Modification to run CPU09CMI on 5MHz bus. Read FLP_MRDY.

On top side:

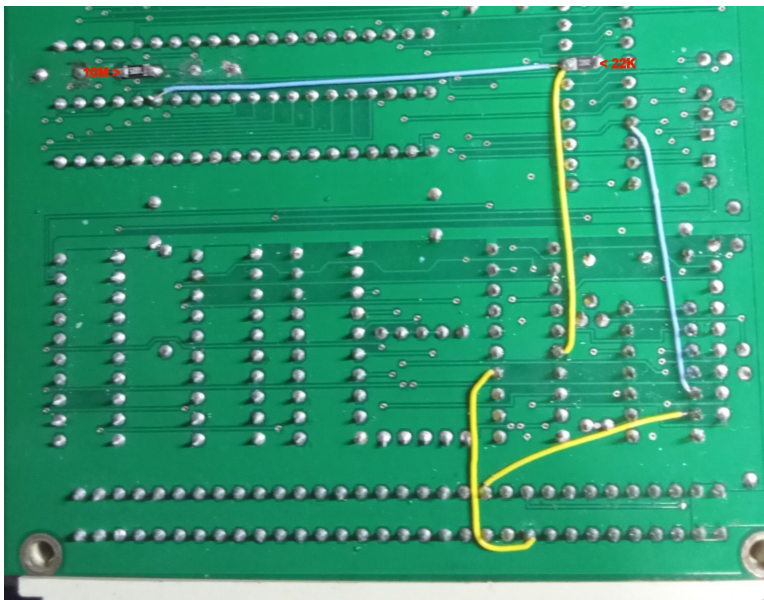
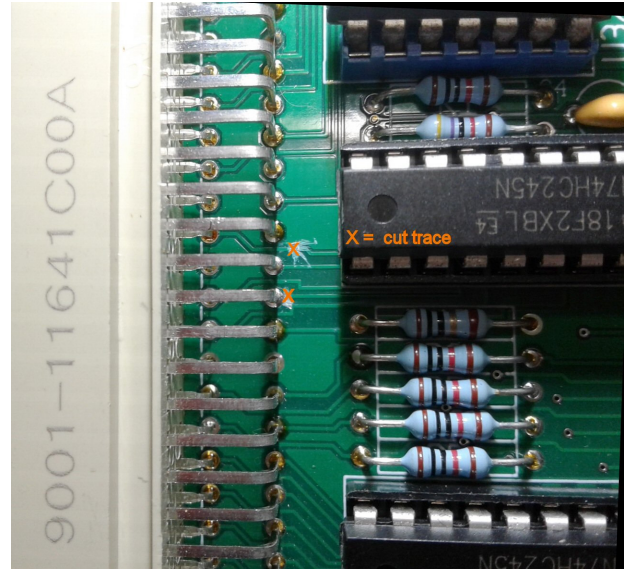
Cut trace between U4-14 and J1 C-21 (B_VMA-)

For REV:0.9 print only cut trace from J1 A23 to R15

On solder side:

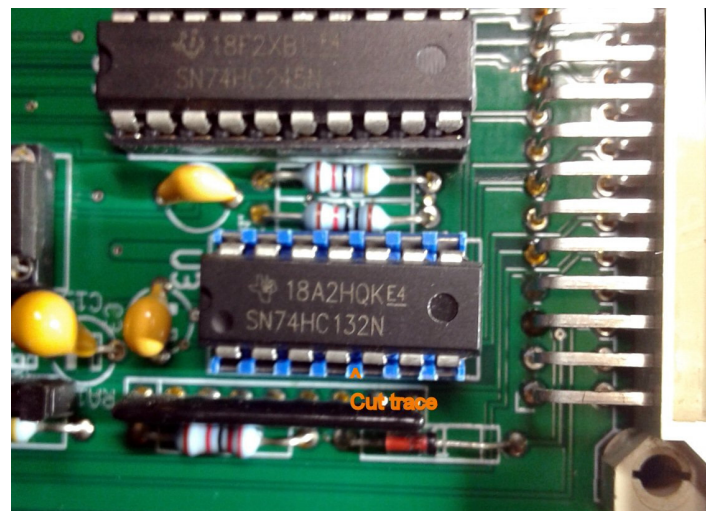
Cut trace between U13-19 and via (OVMA-)

Place 22K resistor between U13-19 and Gnd

Place wire from U6-35 to U13-19 (blue) and U4-6 (Q) (yellow)

Place wire from U4-14 to J1 A-23 (B_Q) (yellow)

Place wire from U3-7 to J1 C-21 (B_VMA-), **Or:**
To keep CPU09CMI 68x02 compatible
or need VMA- signal with 68x02 on the bus
for CPU09GPP or CPU09RAM card.
